WICHITA-SEDGWICK COUNTY

TO Mike Lindebak, City Engineering
FROM Louise Olivarez, Senior Planner
SUBJECT S/D 80-16 - Sketch plat - Lifetime Addition

LIFETIME ADDITION

SUBDIVISION REPORT

Lifetime Addn
Attachment 1

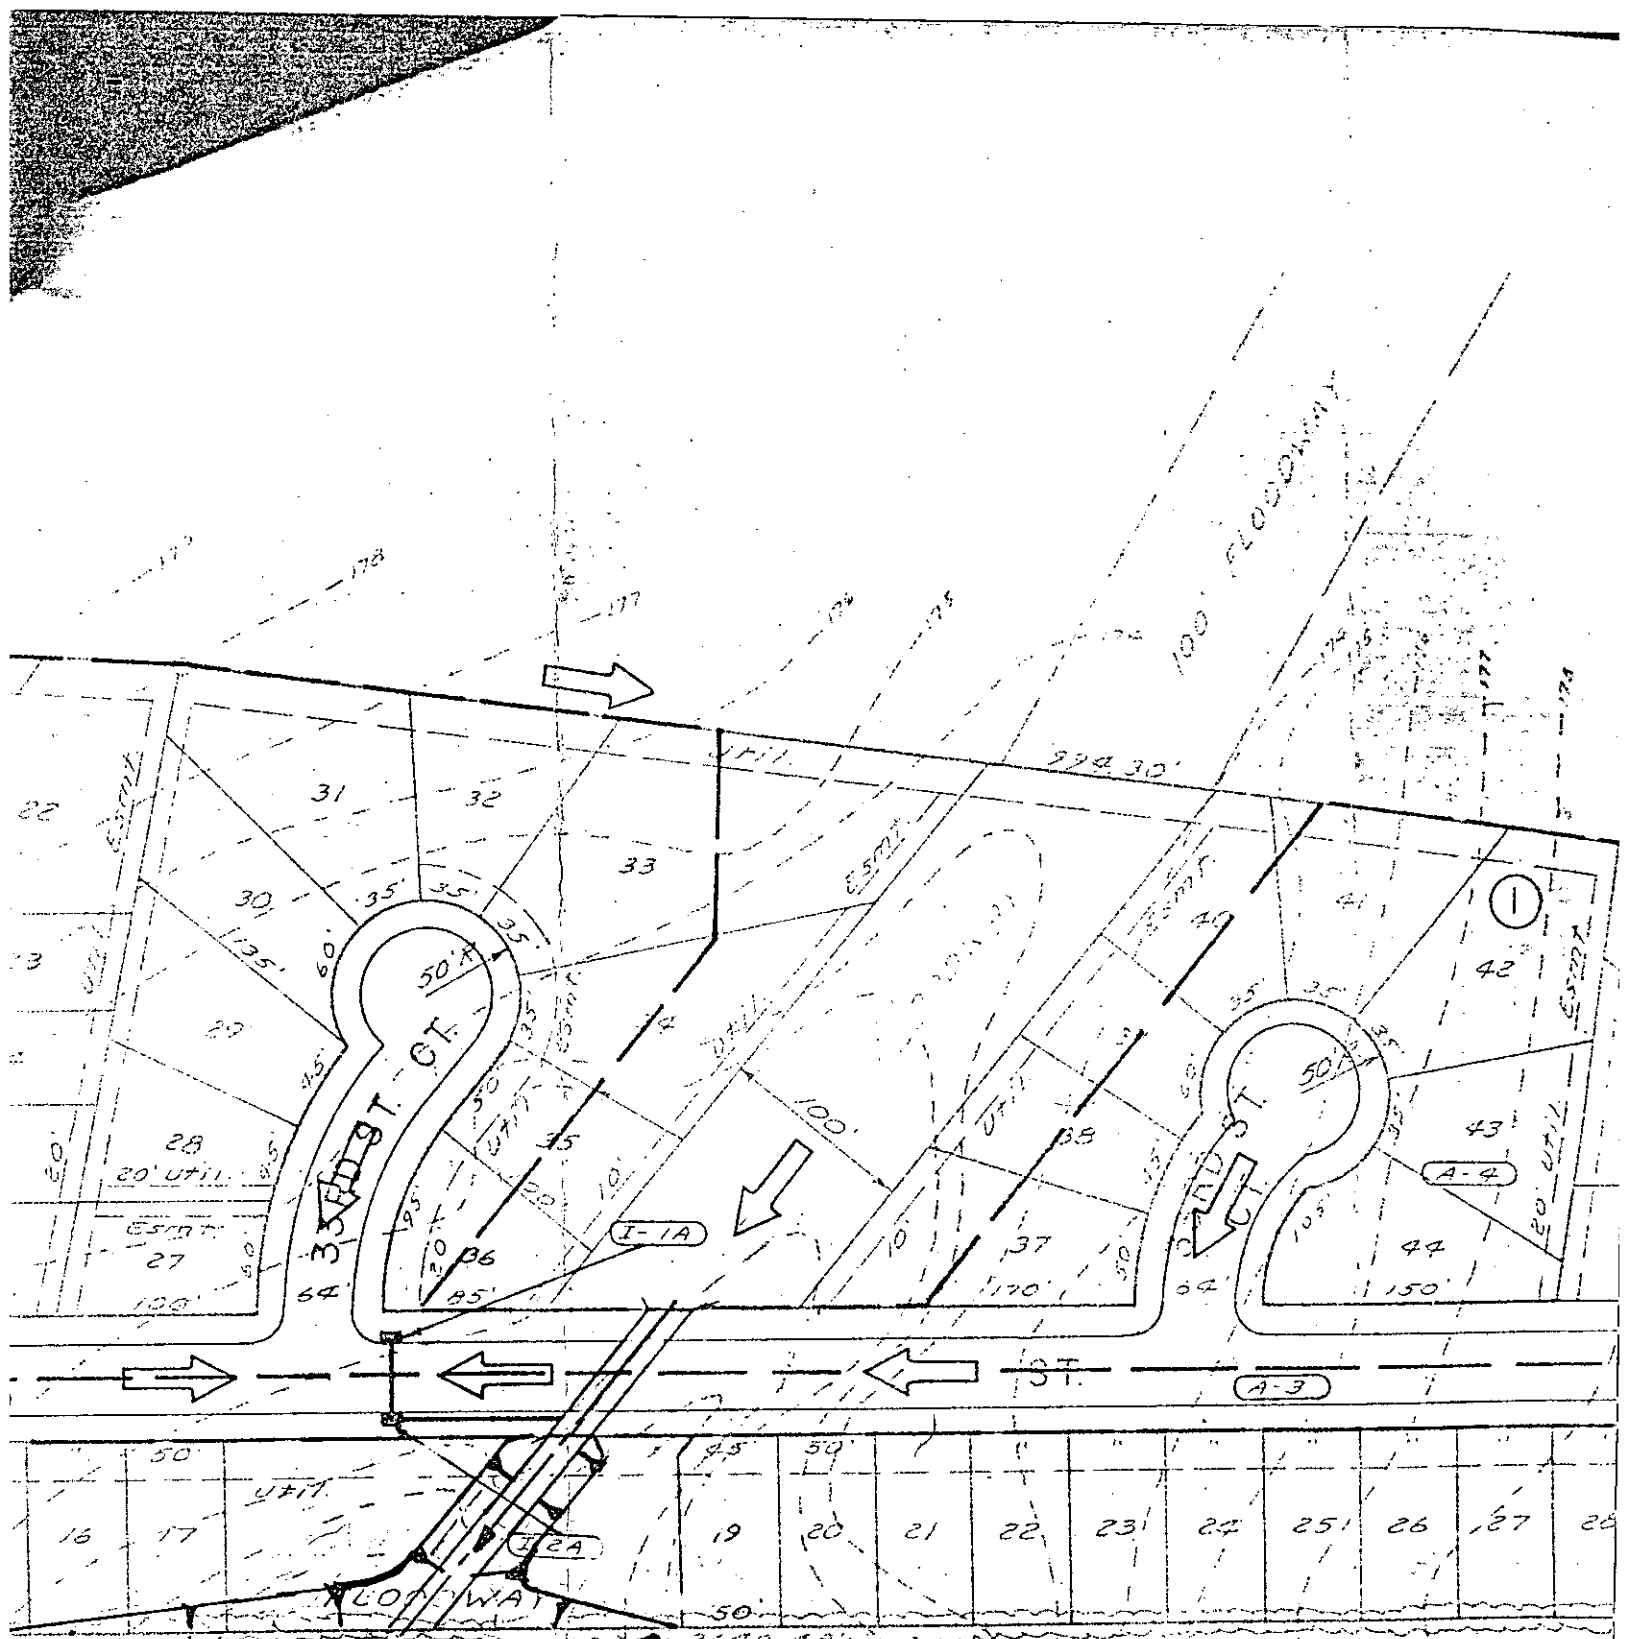
1. Due to experienced high water in subject area, channelization and minimum pad requirements will be necessary.
2. Additional floodway requirements may be necessary at the south edge of the property (see attachment 1) to provide the necessary transition between an approved channel and the existing topography of the property just south of subject plat.

Possible need for
addn Floodway requirements

Drainage Easements by Separate Instrument

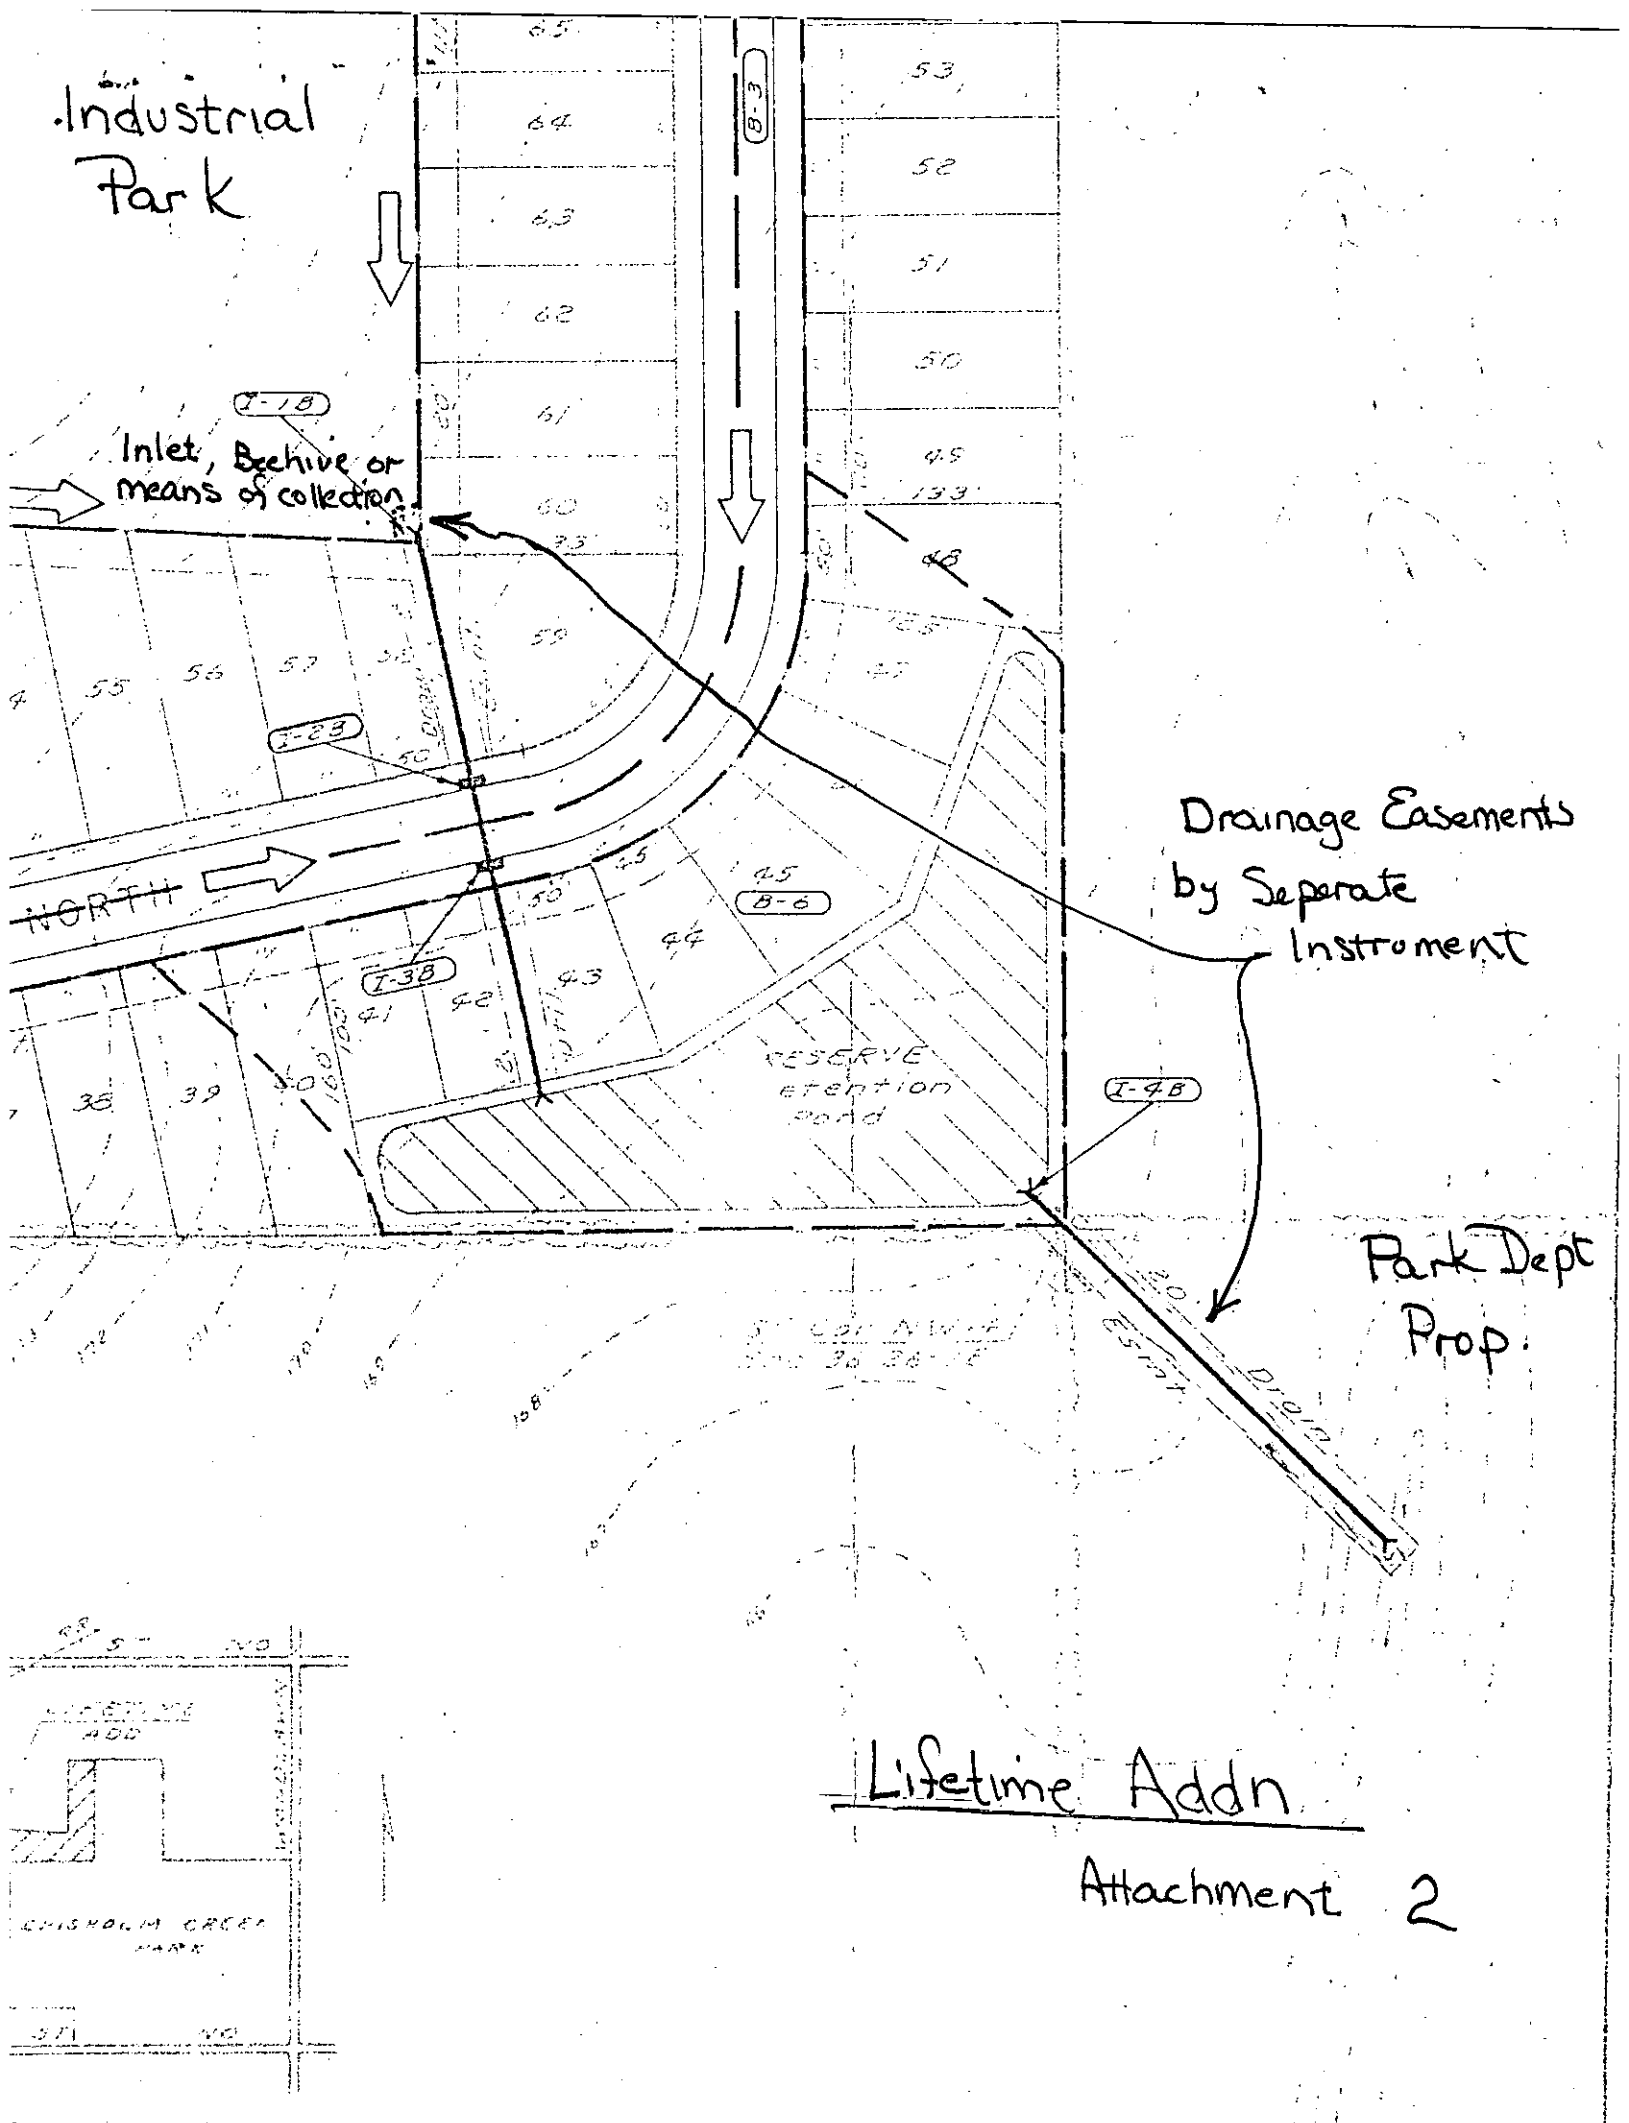
3. Drainage easements by separate instrument should be secured from the industrial park to the north and the Park Department to the southeast to provide for both the inlet and outfall structures (attachment 2).

Industrial Park
